Village of Mukwonago
Notice of Meeting and Agenda

PLAN COMMISSION MEETING
Tuesday, May 11, 2021

- 5.1 Public Hearing on a request to consider an Amendment to a Planned Unit Development for a 20-Unit addition onto structure Birchrock Properties LLC, applicant; 210 McDivitt Ln; Parcel MUKV 2012-215-002.
[Public Hearing Notice PC -CU - Birchrock -210 McDivitt - MUKV2012215002 \(2\).pdf](#)
- 5.2 Public Hearing to consider a Conditional Use application for a drive-through facility, with a permitted or conditional use Espresso Love, applicant; 301 Main St; Parcel MUKV 1976-128.
[Public Hearing Notice PC -CU- Espresso Love - 301 Main Street - MUKV1976128.pdf](#)

SITE PLAN AND ARCHITECTURAL REVIEW AND CONDITIONAL USE PERMIT

SHEET TITLE:
GRADING AND UTILITY
PLAN

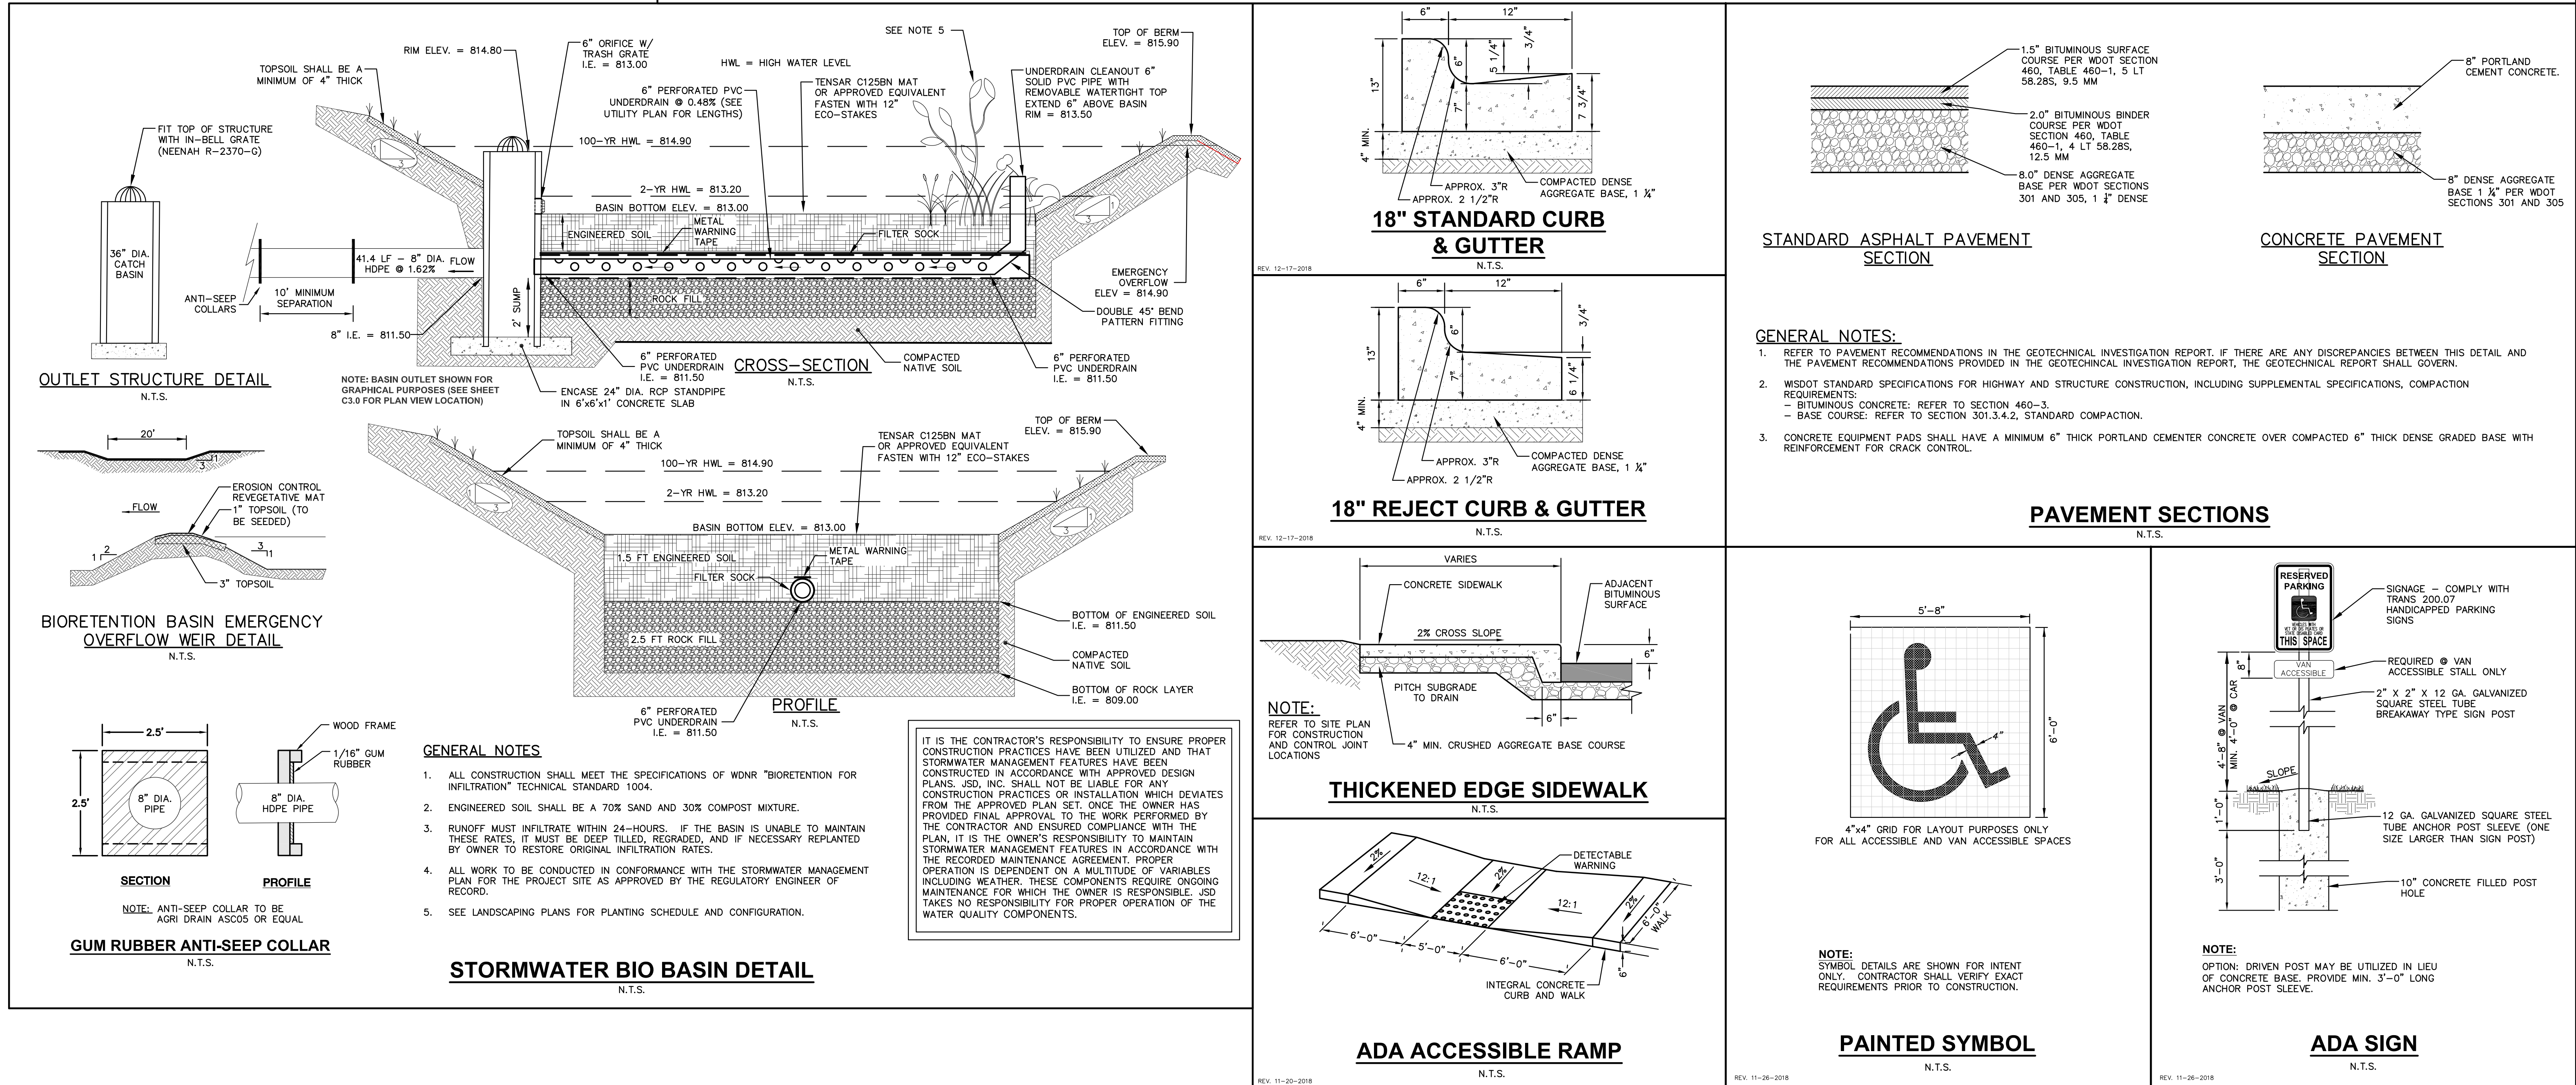
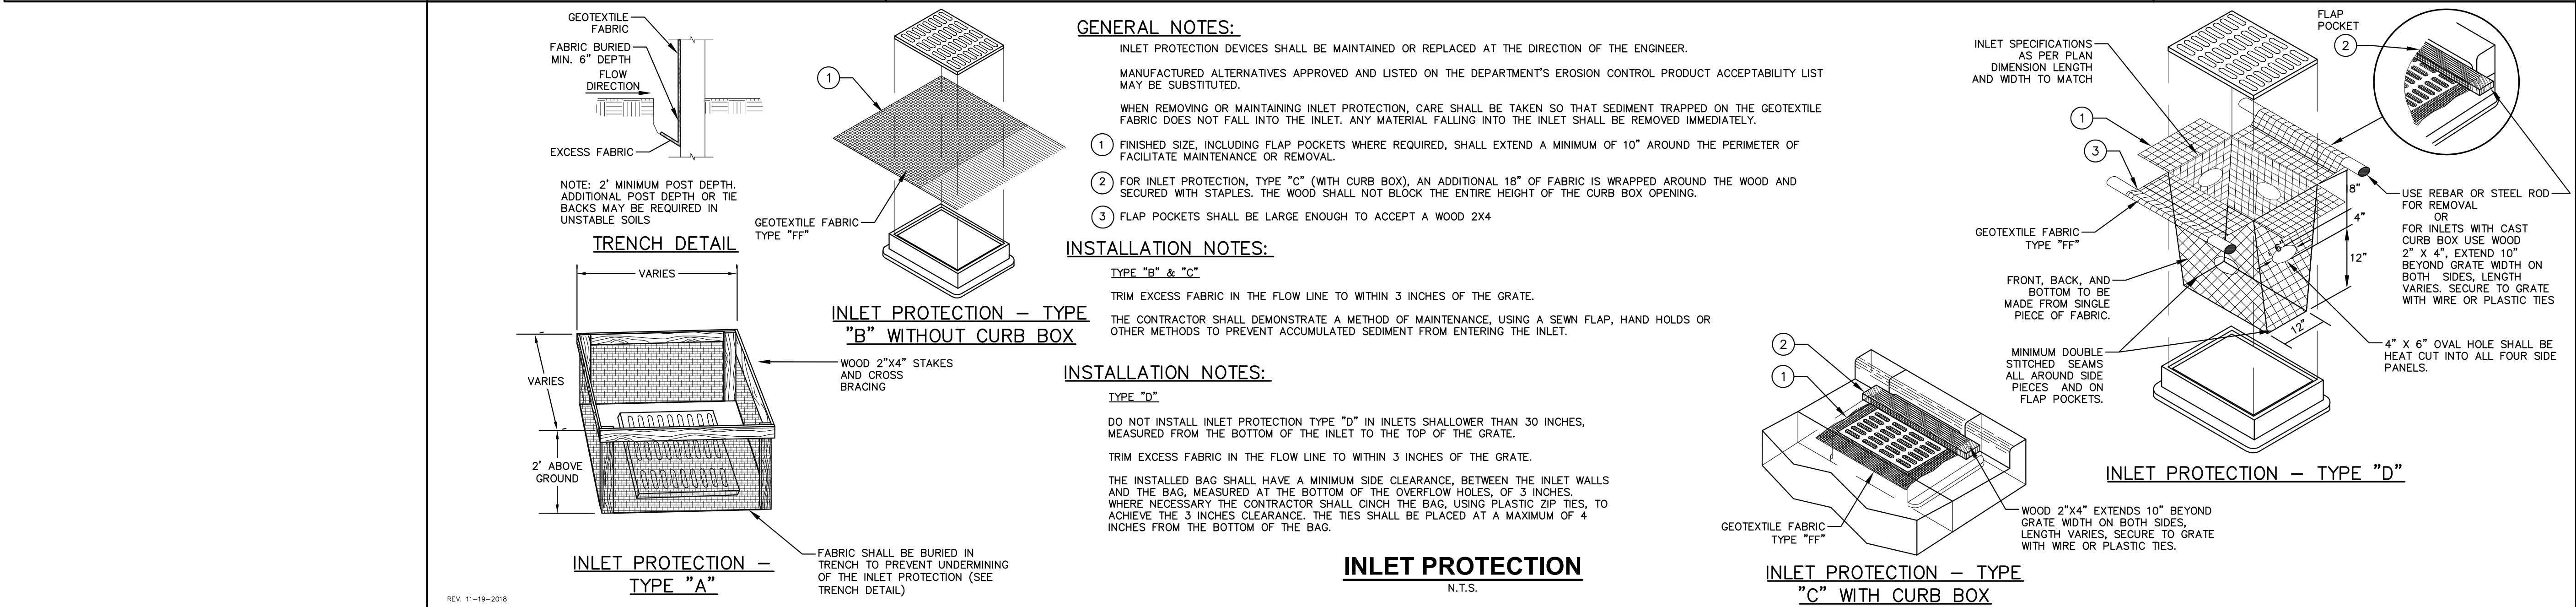
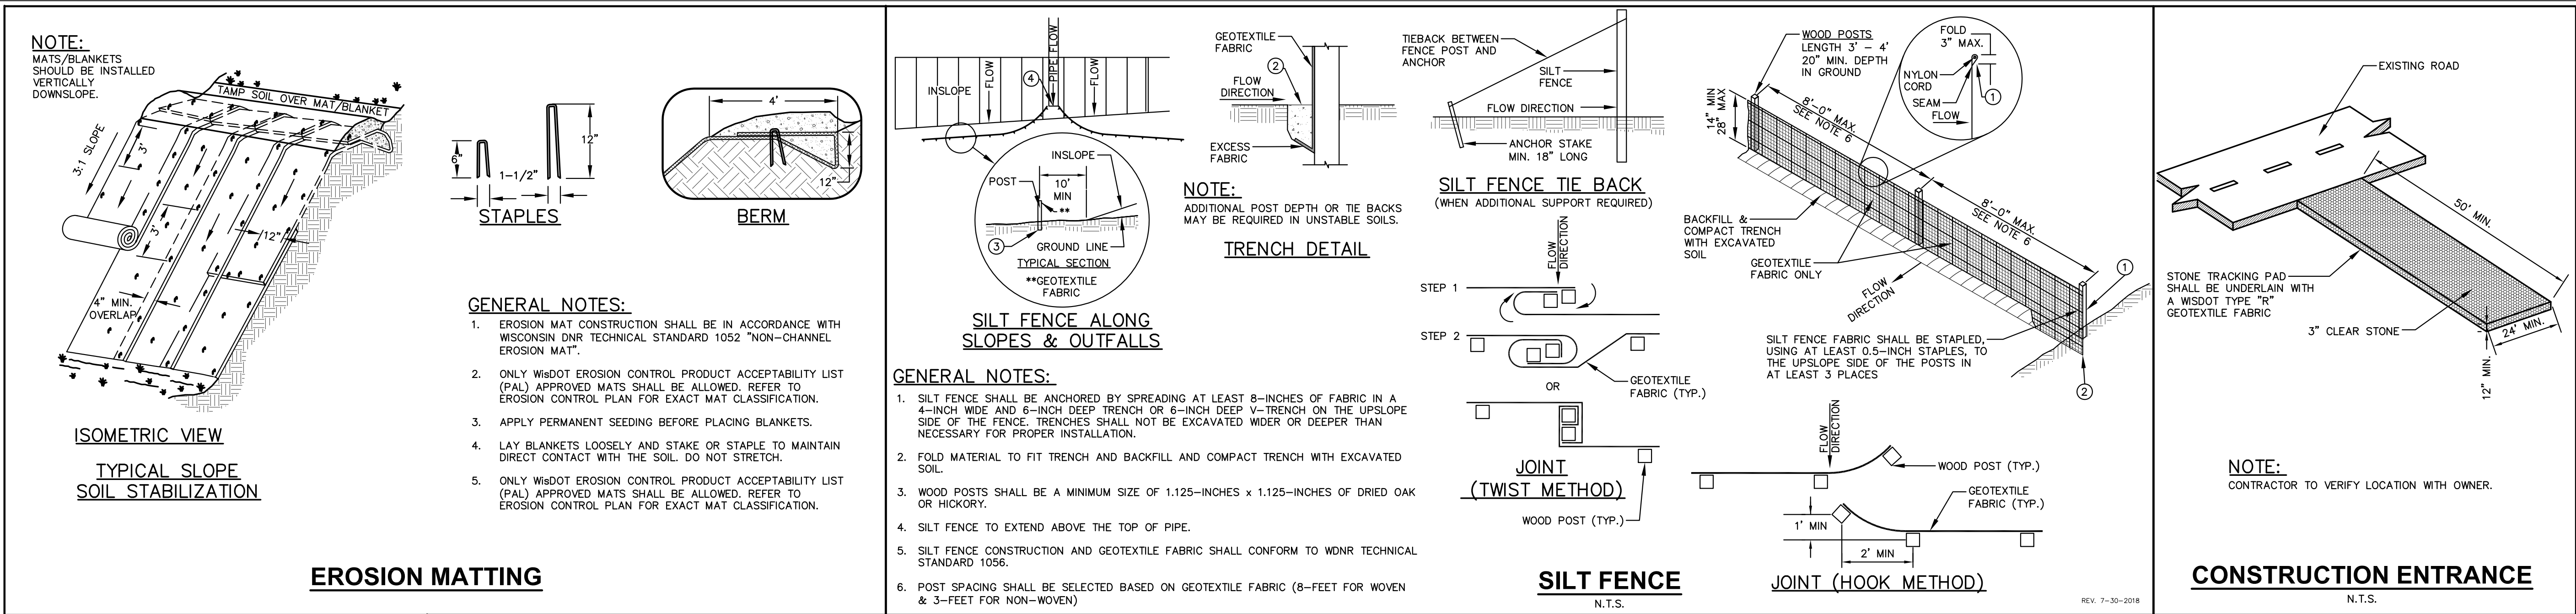
11. Sheet C5.0 – What is the discharge elevation of FES 1-1 and how does it relate to the HWL of the adjacent wetlands? Was any tailwater taken into account and modeled in the storm sewer calculations to ensure that during peak flows and water levels in the wetlands, the biofilter and storm sewer on-site will not be affected?

12. Sheet C5.0 – At storm structure STO 2-4, the rim elevation is 817.17. If this structure becomes clogged, blocked, or overwhelmed, it appears that the adjacent elevation of relief is 817.35. Elevation 817.35 is also the adjacent building corner grade. Other adjacent elevations of relief to the overland flow path are 817.44, which is subsequently also the elevation of another adjacent building corner. The FFE of the building is at an elevation of 817.52. Ideally, there should be at least 6-inches of freeboard between any occupied structure or electrical pedestal and the highest water level, and it appears that this will not be achieved at this location.

13. Sheet C5.0 – At storm structure STO 2-7 the sidewalk adjacent to the parking lot is located nearly 2-feet higher at 818.50 than the structure’s rim elevation at 816.67. If this structure becomes clogged, blocked, or overwhelmed, it appears that the adjacent elevation of relief is through the building with a FFE of 817.52. Again, there does not appear to be 6-inches of freeboard between the building and the highest water level and the building will become flooded.

14. Sheet C5.0 – At storm structure STO 2-8, the rim elevation is 815.40. If this structure becomes clogged, blocked, or overwhelmed, the highest elevation that overland flow must overcome, away from the building, is 816.20. It appears that the adjacent elevation of relief is through the building at an elevation of 815.52. The overland flow route should not be through any occupied structure.

15. Sheet C5.0 – At storm structure STO 2-2, the rim elevation is 817.25. Assuming that this grade is the flange elevation, the back of curb, which also happens to be the elevation that must be overcome for the overland flow route, would be at an elevation of 817.69. If this structure becomes clogged, blocked, or overwhelmed, it appears that the overland flow route will flow down the handicap ramp and sidewalk before gaining relief.

16. Sheet C5.0 – There appears to be high point in the parking lot along the overland flow path of 817.90. Assuming that the elevation at the far northeast corner of the parking lot, along the overland flow path in that direction is the flange elevation, the elevation of relief at that location is 817.79. It is recommended adjusting the high point in the parking lot to provide a greater flow of relief to the west if the parking lot around storm structure STO 2-3 should flood. In the event that water cannot escape at the exact northeast corner of the parking lot, water may begin to overtop the curb near the ADA accessible parking stalls which would result in flows towards the building.

17. Sheet C5.0 – Is storm structure STO 3-2 capable of capturing and conveying all flows within the existing building courtyard? If this structure becomes clogged or inundated, at what elevation will storm water pond within the courtyard? There does not appear to be any overland relief for this area, and it's pertinent that the addition of the building connector does not cause the courtyard to trap storm water resulting in building flooding. Does the tailwater in the adjacent wetland affect flow through this storm pipe?
